STAFF REPORT

REGIONAL CENTER HEARING EXAMINER - HIGH IMPACT CASE

Case Number	2026-REG-044
Address (approx.)	2955 North Meridian Street
Location	Center Township, Council District #12
Petitioner	2955 Indy IN, LLC, by Michael Rabinowitch
Zoning	C-S (TOD) (RC)
Request	Regional Center Approval for provide for a new-construction bank with surface parking and pedestrian connections.

August 14th, 2026, Design –

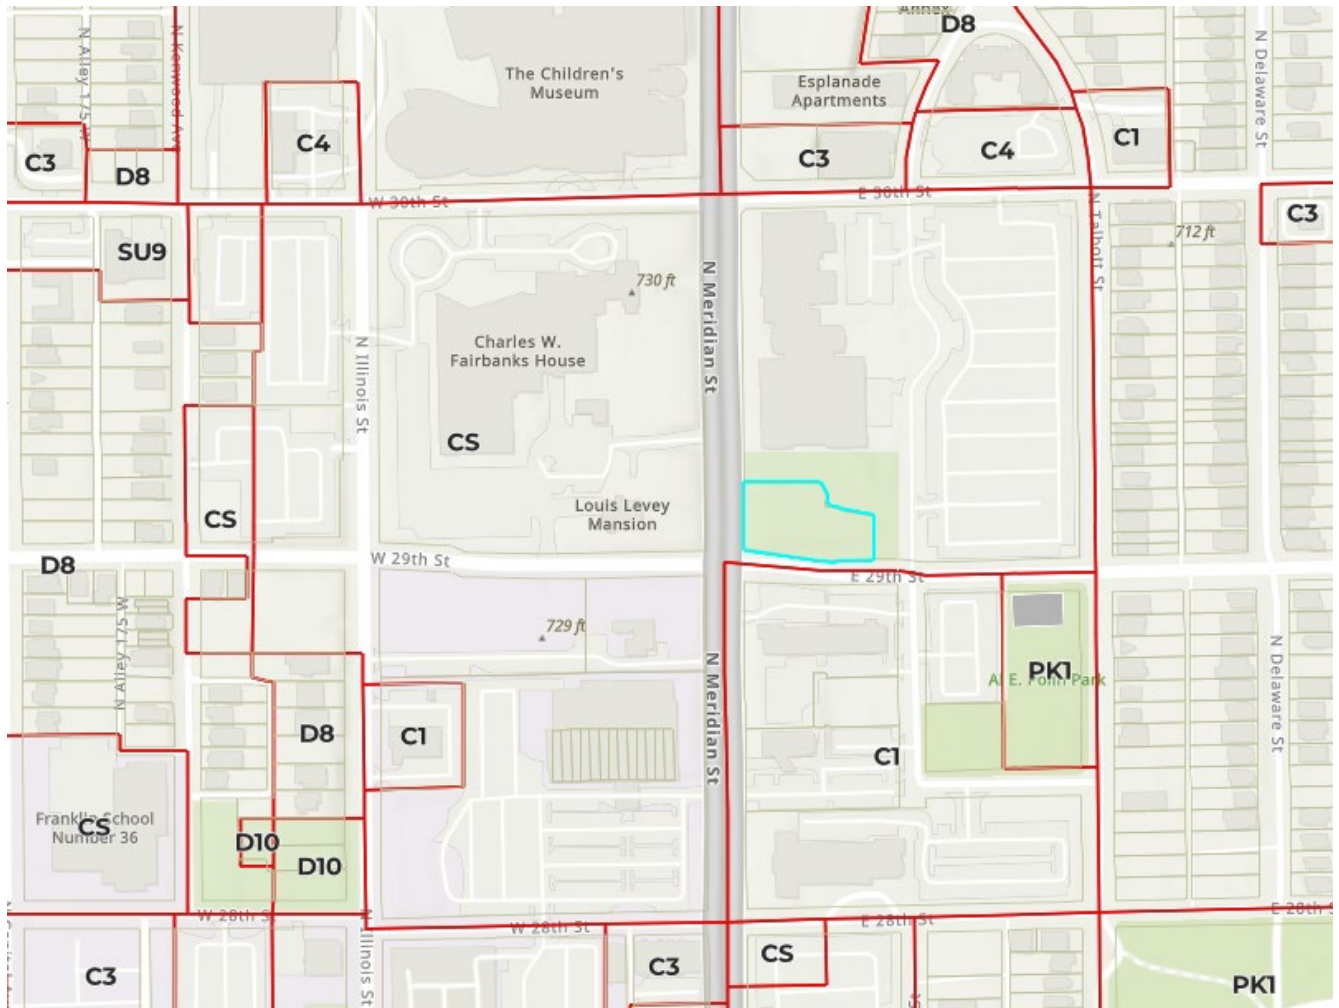
The initial design was located within the clear sight triangle. Additionally, the required transparency levels were not met along the 29th Street and Meridian Street elevations.

In the August 14, 2026, design, the building was moved outside of the clear sight triangle requirements, and transparency along the 29th Street elevation was improved. The scuppers located on the elevation fronting Meridian Street were also removed. Additionally, screening was added for the mechanical equipment along Meridian Street.

Proposed elevations for the bank

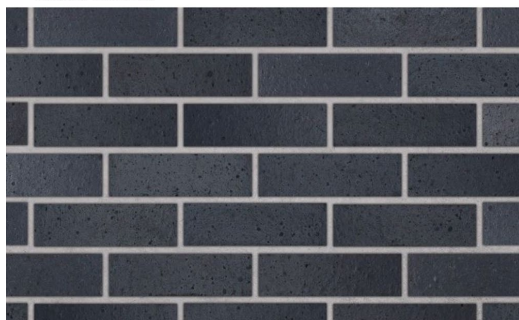
1. Bright colors are utilized on more than five percent of the building façade; however, the proposed color palette and materials are compatible with the character of the Regional Center urban environment. CA 2.2.2
